Date: 03/23/18
To: TRLR45/TRLR70US Trailer Owners
From: Multiquip Product Department
Subject: Trailer Frame Reinforcement — **Mandatory Update**

TRLR45/TRLR70US Gusset Installation

Product Group: Trailers	Date Issued: 03/23/18	Expiration Date: 03/23/19	Service Bulletin No. TL20180306
Bulletin Type ☒ Mandatory ☐ Information Only ☐ Recommended Change		Models/Series Affected: TRLR45 VIN L021853, L021854, L021855, L021856, L021857, L021858, and L021873 TRLR70US VIN L021931, L021932, L021933, L021934, L021936, and L021937

Figure 1. Gussets

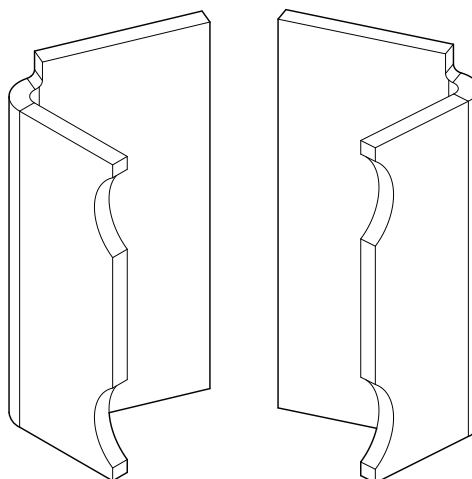
Improve existing trailer design.

Install trailer reinforcement gussets.

Table 1. Gusset Installation Kit				
Item No.	Part No.	Description	Qty.	Remarks
1	49941-02	Gusset, Jack Crossmember, TRLR45	2	TRLR45 only
1	49927-02	Gusset, Jack Crossmember, TRLR70	2	TRLR70 only

Figure 4. Gusset Placement

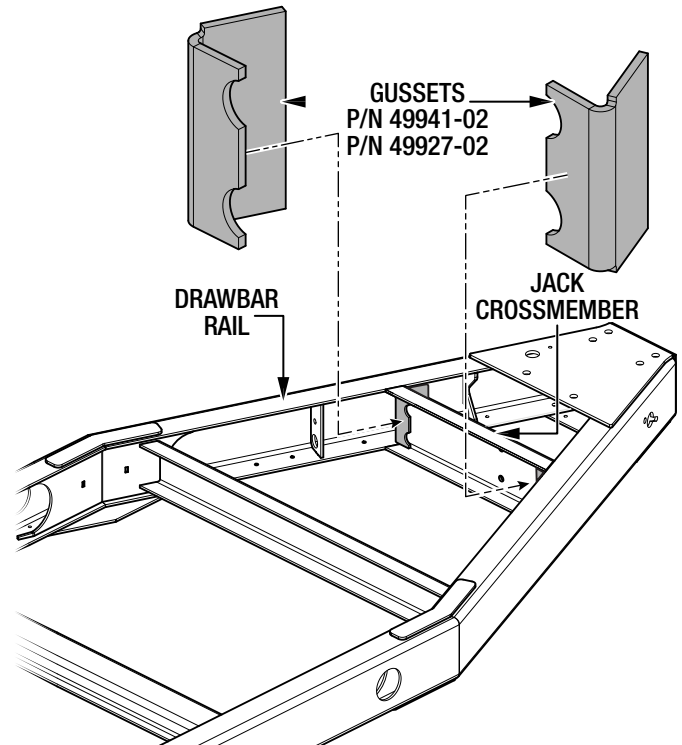
1. Place the gusset (P/N 49941-02 or P/N 49927-02) between the jack crossmember and drawbar rail as shown in Figure 4.

Figure 6. Gusset Welding

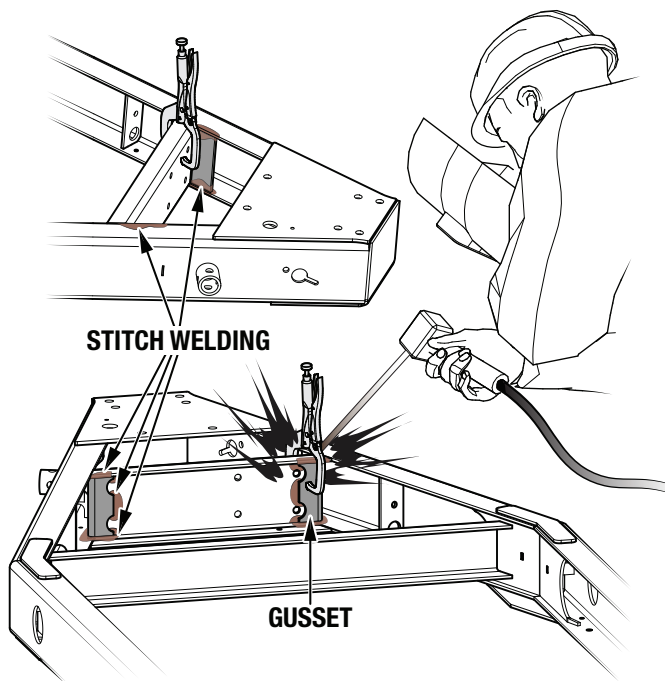
3. Weld the gusset to the trailer frame (Figure 6).

4. Repeat steps 1–3 with the second gusset on the opposite side of the trailer frame.
5. At the completion of the welding process, remove any flux, burrs, or rough edges from the welding area.
